BOOTS THE CHEMIST REVISED SIGNAGE PROPOSAL STORE 1126: KINGS CROSS.

Revision A

Issued - by CGL Architects

Existing Elevation: streetside.

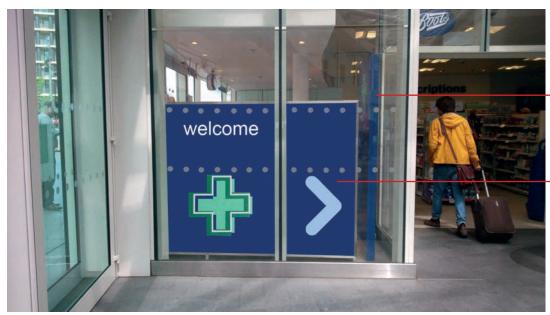
Existing Boots lozenge and dark blue lettering to remain unchanged.

Existing order and collect signage and all paper signage to be removed from the shop front glazing.

Existing internal totem to be over clad with dark blue vinyl welcome panel.

Existing Elevation: concourse.

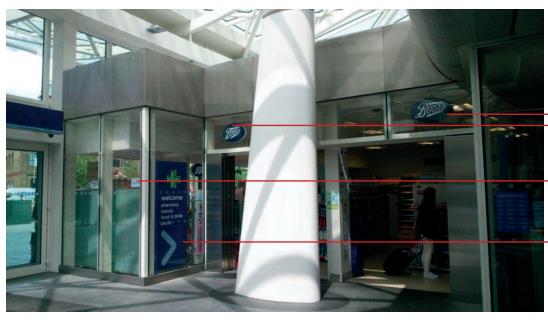
Existing bus stop signs over tops of gondolas to be removed. Also any internal directional signage to this area to be removed.

Existing welcome panel to be replaced with new - like for like, but to include "order and collect" lettering.

- Existing gondola end to be over clad in dark blue vinyl (RAL P280C) and white lettering to say "welcome", pale blue arrow (RAL P277C) and Boots green cross. All non-illuminated.
